CR245 – Side stand replacement

DesertX Model Year 2023 (all country versions)

Technical Service Bulletin SRV-TSB-23-002

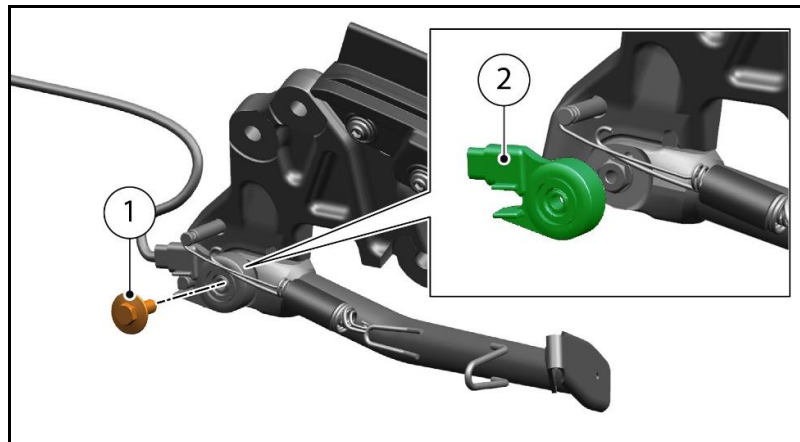
We would like to inform you that a new side stand (**Part no. 55611291CA**) with a different length and geometry than the current one has been introduced into production (from frame number ZDMxxxxxxx006182, produced on 02/12/2022). This update will facilitate the stability of the motorcycle in non-level ground conditions.

The new side stand has punched the last digits of its spare part number "**129.1C**" at the top, as shown in the figure.
